WATER QUALITY MEMORANDUM Utah Coal Regulatory Program

April 15, 2010

RE: 2009, 2nd Quarter Water Monitoring, Canyon Fuel Company (CFC), LLC,
Dugout Mine, C/007/0039-WQ09-2, Task ID #3326

UPDES Outfall 001: T-Fe vs. Time

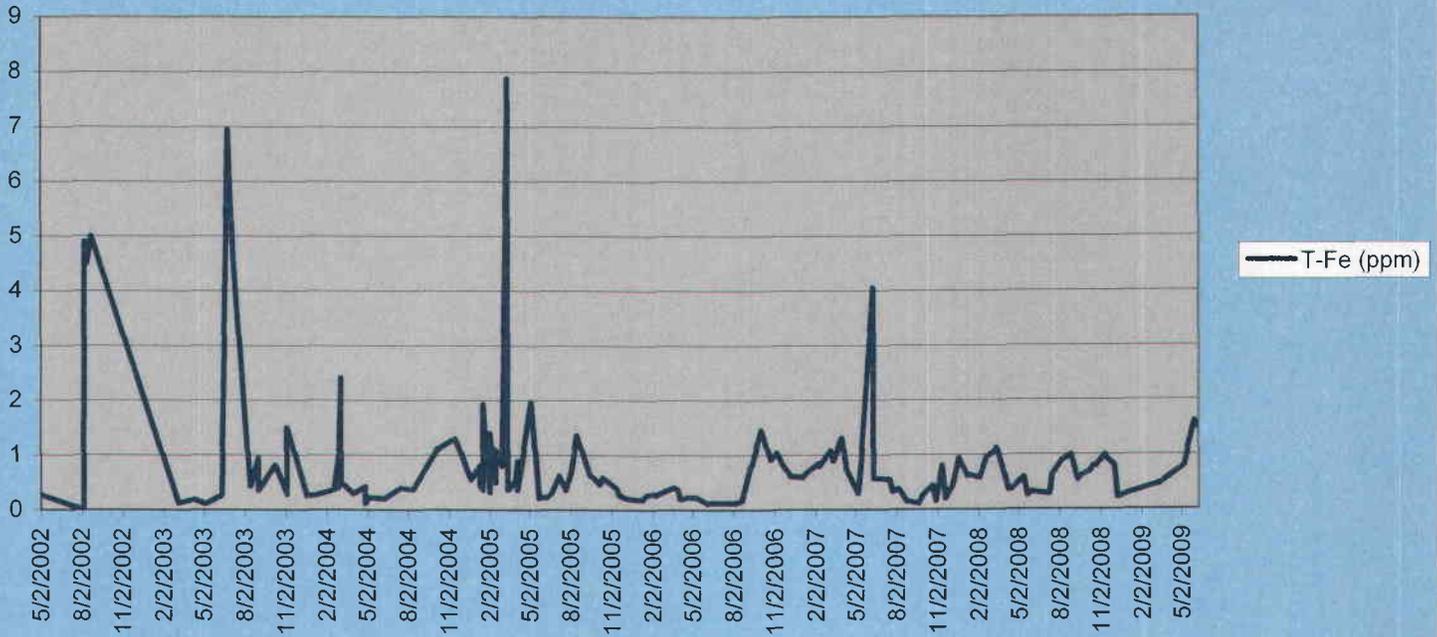
Site 001 averaged a flow of 156 gallons per minute (gpm). Of seven sampling events, two total iron (T-Fe) concentrations were reported outside of the compliance level established in the Permittee's UPDES permit (1.1 ppm). (See Chart Below)

Monitoring Well GW-10-2

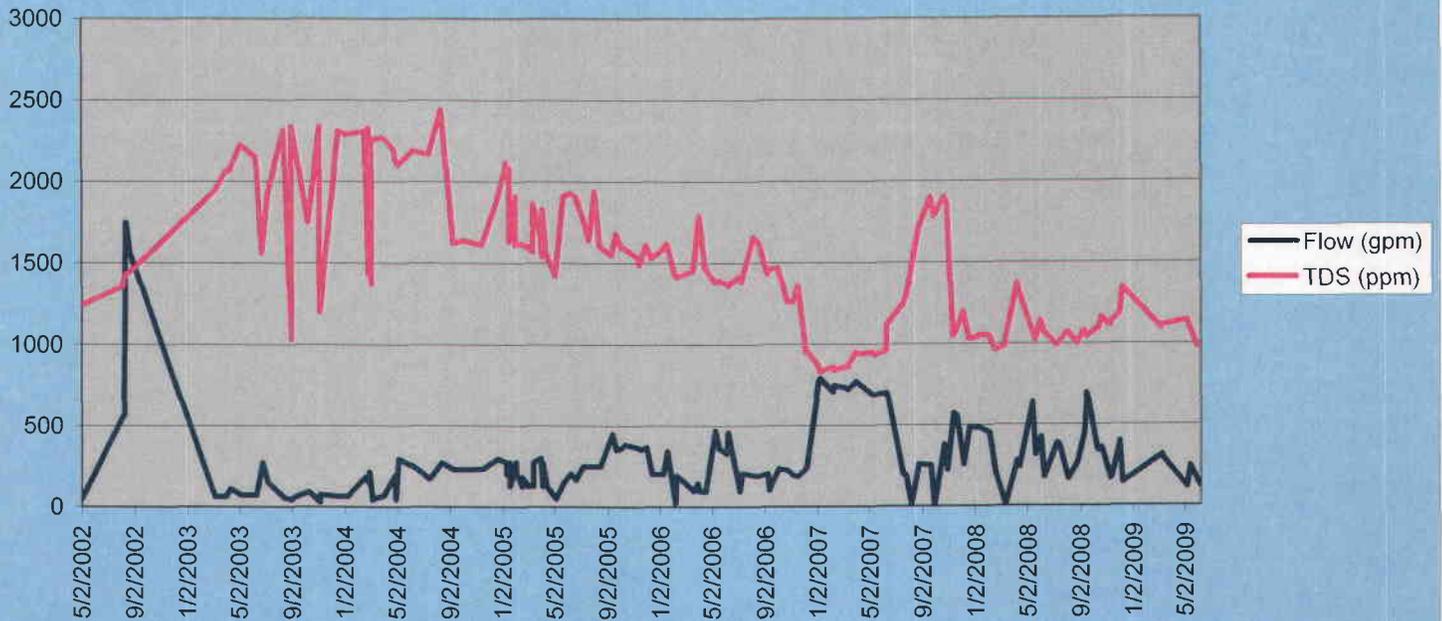
Monitoring well GW-10-2 reported a depth to water that was outside of two standard deviations (747.58') during the fourth quarter of 2008 (WQ 08-4). The well was inaccessible due to snow conditions the first quarter of 2009. The reported depth to water for this quarter was within two standard deviations of the mean. (See Chart Below).

DC-1: D-Na, TDS and Flow vs. Time

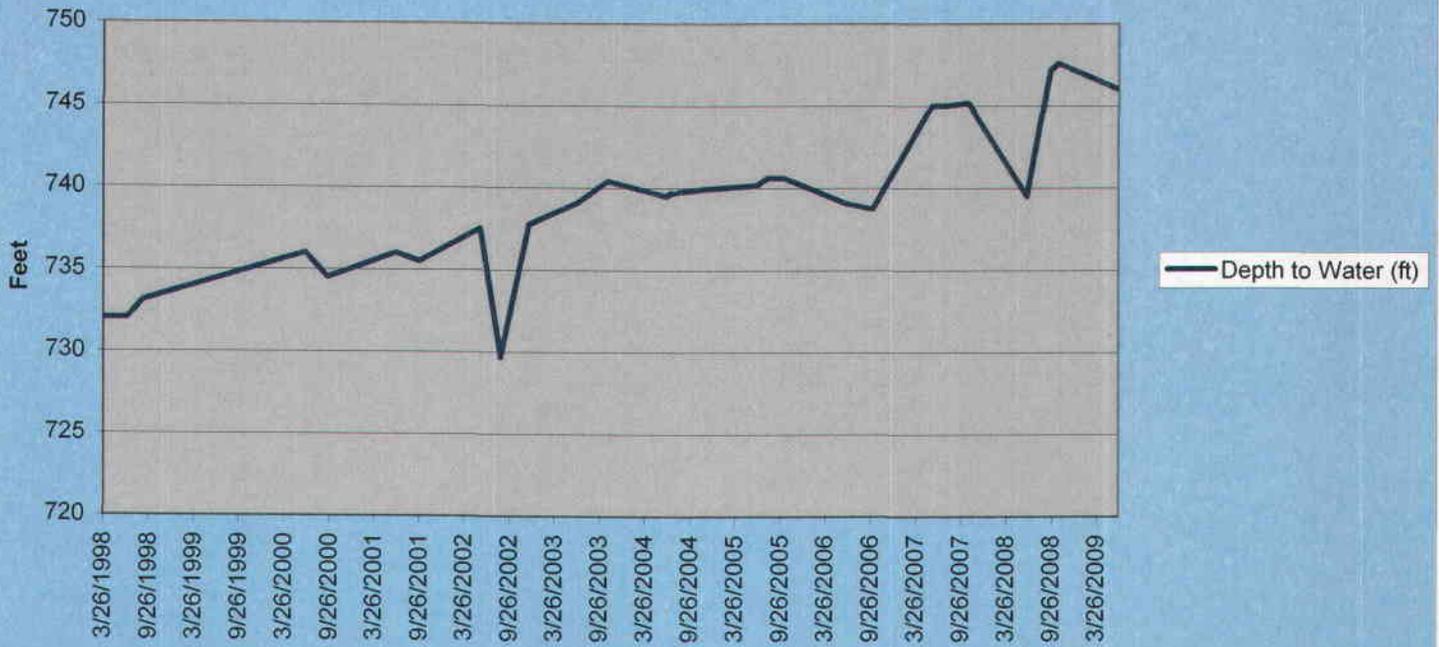
DC-1 had reported elevated D-Na concentrations the previous two quarters (WQ08-4 and WQ09-1). The reported D-Na concentration for this quarter was back to within two standard deviations of the mean. The D-Na concentrations at this surface water monitoring point have historically been erratic (See Chart Below). Based upon the data set, it appears that the D-Na concentrations tend to spike during the spring and early summer, presumably as a result of snowmelt.
